Project	IEEE 802.16 Broadband Wireless Access Working Group < http://ieee802.org/16 >	
Title	High Girth LDPC Coding for OFDMA PHY	
Date Submitted	2005-01-10	
Source(s)	Robert Xu, David Yuan, Li Zeng ZTE Corporation 3/F, Bldg.711, Pengji Industrial Park, Liantang, Shenzhen, 518004, P.R.China	Voice: +86 755 26773000 6574 Fax: +86 755 26773000 6616 mailto: xu.jun2@zte.com.cn yuan.liuqing@zte.com.cn
Re:	Response to Sponsor Ballot on IEEE802.16e/D5a document	
Abstract	High girth LDPC codes design technologies are introduced into the contribution for the first time, to overcome the “error floor” phenomenon, and enhance the BER curve descending speed when SNR is high. Also it has a performance improvement over the LDPC codes proposed in the previous contribution “IEEE C802.16e-04/373r1”, which is supported by 6 of the 8 companies that provided LDPC proposals to an informal LDPC group.	
Purpose	To incorporate the text changes proposed in this contribution into the 802.16e/D6 draft.

High Girth LDPC Coding for OFDMA PHY

Fig. 2 Block diagram of the encoder architecture for the block LDPC code.

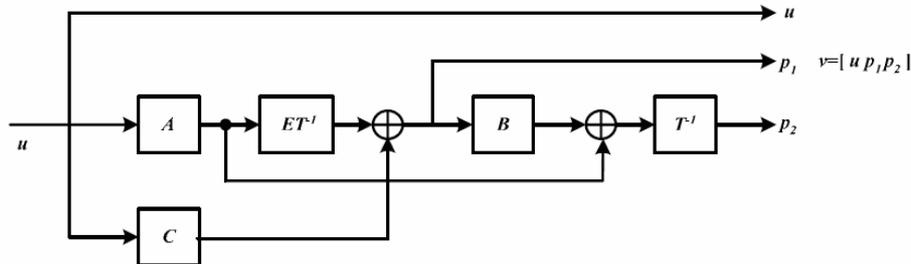
As a result, the encoding procedures and the corresponding operations can be summarized below and illustrated in Fig. 2.

Encoding procedure

Step 1) Compute Au^T and Cu^T .

Step 2) Compute $ET^{-1}(Au^T)$.

Step 3) Compute p_1^T by $p_1^T = ET^{-1}(Au^T) + Cu^T$.

Step 4) Compute p_2^T by $Tp_2^T = Au^T + Bp_1^T$.
